ADDENDUM NO. 1
KINGSBURY CREEK WATERMAIN RELOCATIONS AT GRAND AVENUE
CITY OF DULUTH
BID NO. 14-0306, PROJECT NO. 1078
BID OPENING DATE: 2:00 PM , July 10, 2014
Date: July 2, 2014

NOTICE

WEST SIDE
20"/24" WATER CONNECTION DETAILS
 NO SCALE

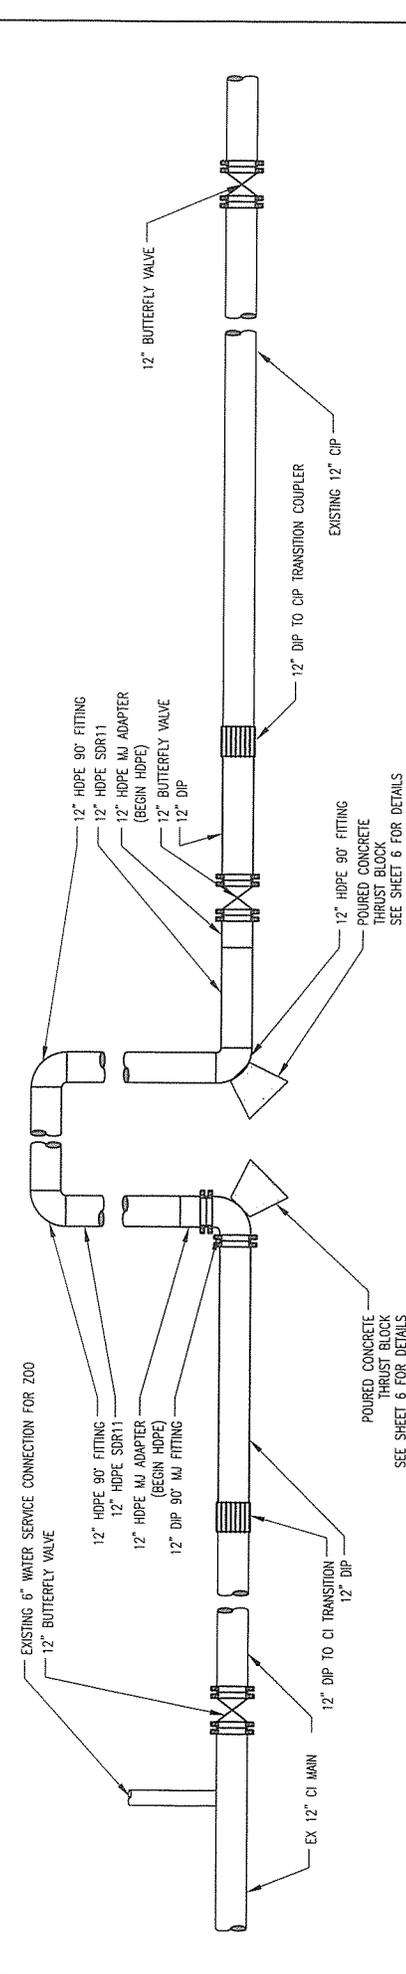
Sheet 7, Water Connection Details and Sheet 12, Water Plan & Profile have been modified with the addition of a 20" butterfly valve and deletion of 24' butterfly valve and fittings. **REPLACE**, the existing plan sheets with revised attached sheets.

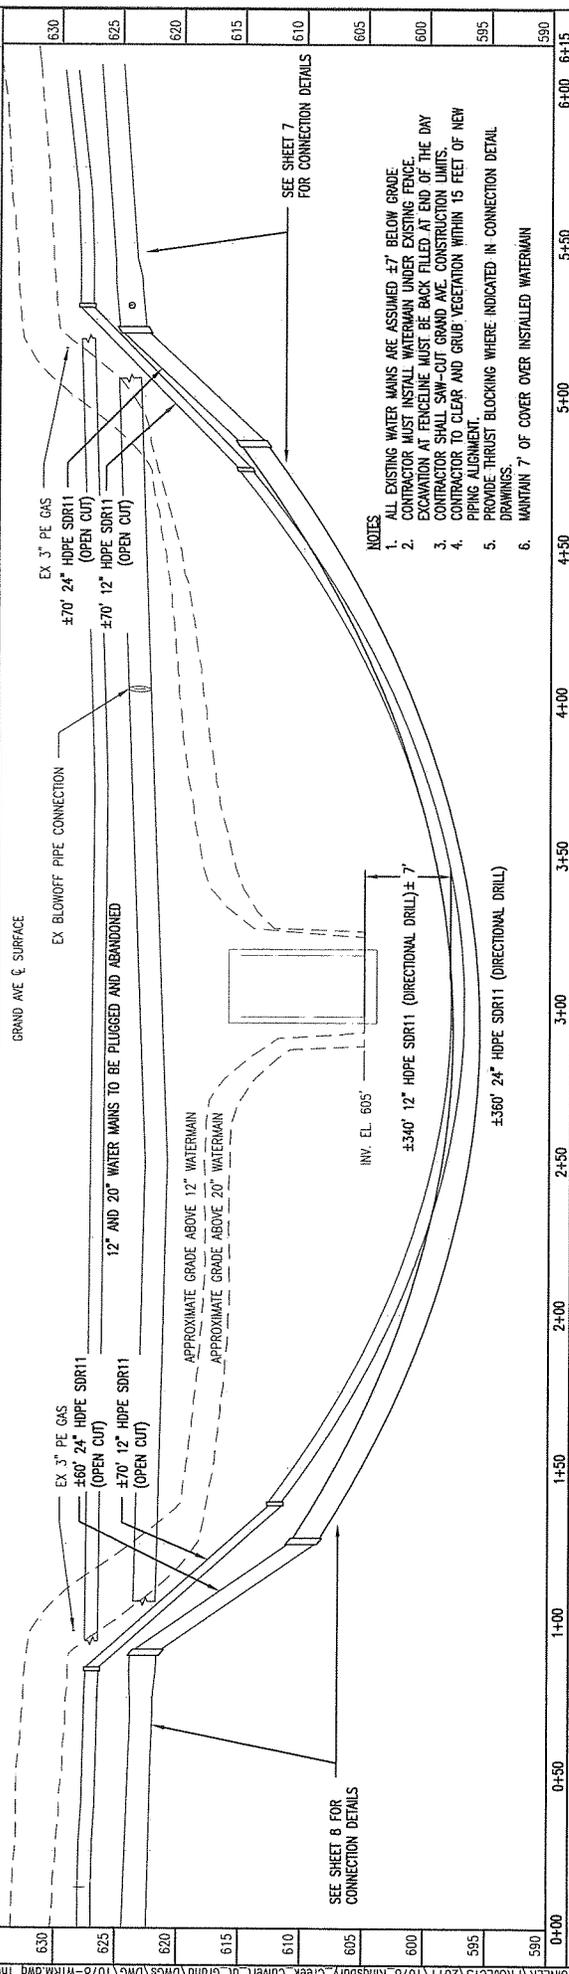
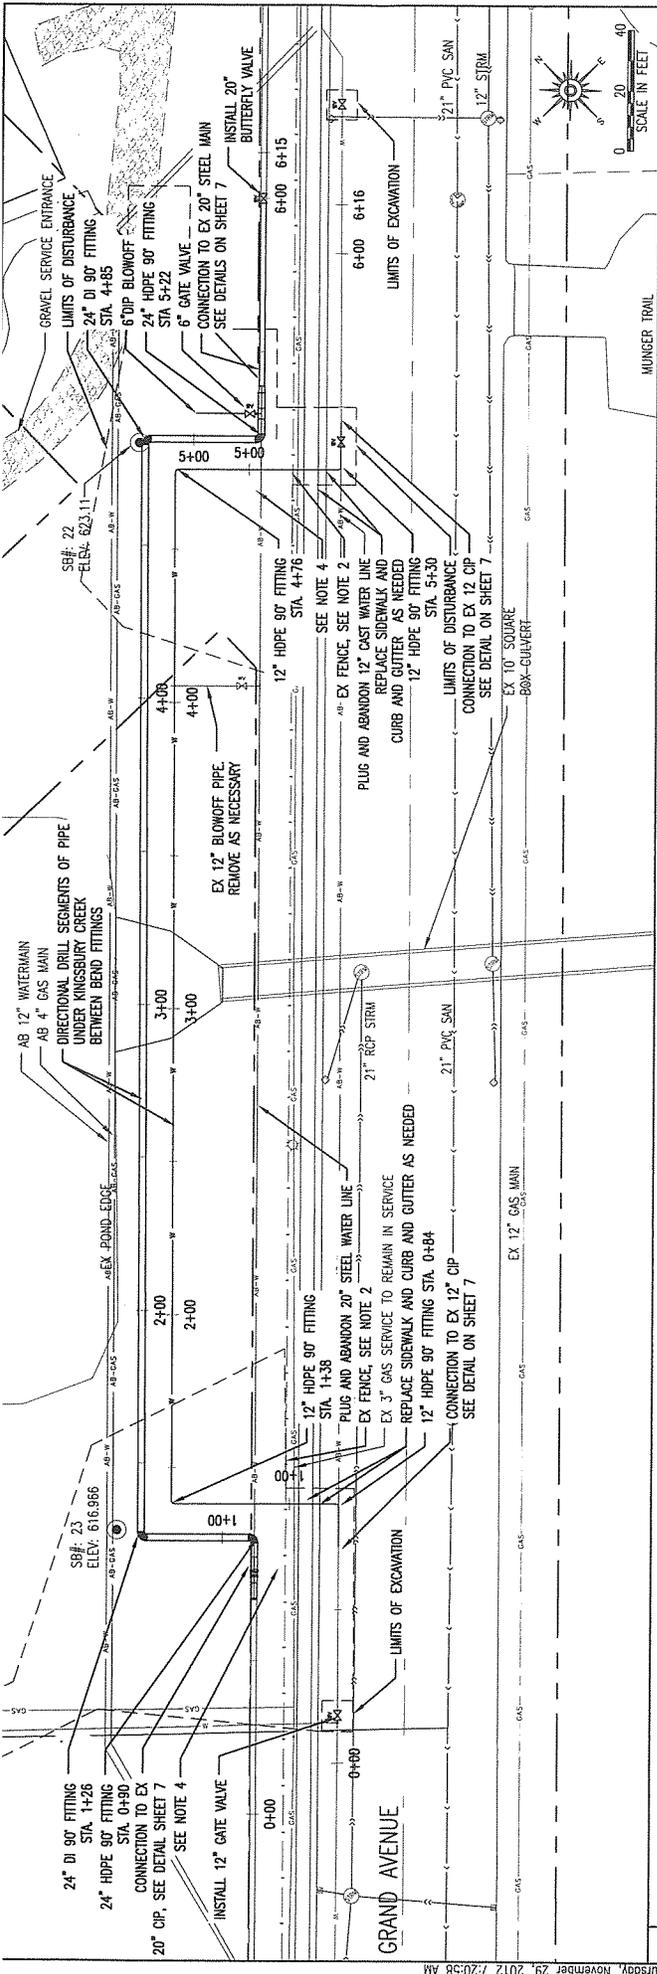
5. The first construction activity is to install a 20" butterfly valve at station 6+00. Once complete, the valves at 63rd Avenue West and Grand Avenue, Polk Street and Grand Avenue and 67th Avenue West and Grand Opening can be opened so the Little Red Store (7002 Grand Avenue) and Bethany Baptist Church (6700 Grand Avenue) are back on water.
